DESIGN <i>[Signature]</i>	DRAWN BY RF	DART AEROSPACE LTD HAWKESBURY, ONTARIO, CANADA	
CHECKED <i>[Signature]</i>	APPROVED <i>[Signature]</i>	DRAWING NO. DEO 9176	REV. A SHEET 1 OF 1
DATE 99.12.10		TITLE ADDITIONAL WEARPLATES	SCALE NTS
A	99.12.10	NEW ISSUE

DART ENGINEERING ORDER

TO AMEND DRAWING D2577 REV. D

FIGURE 1

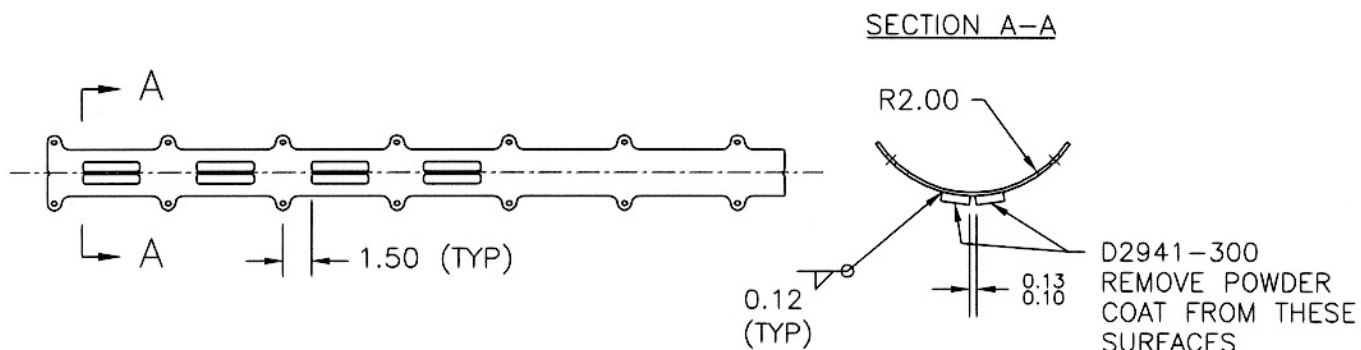
SAME AS D2577-1 EXCEPT THAT 7560 HARDCOAT WELDS ARE REPLACED BY D2941-300 SHWAYDER™ WEARPADS AS SHOWN IN FIGURE 1, JOGGLE IS NOT SHOWN FOR CLARITY.

SAME AS D2577-3 EXCEPT THAT 7560 HARDCOAT WELDS ARE REPLACED BY D2941-300 SHWAYDER™ WEARPADS AS SHOWN IN FIGURE 1.
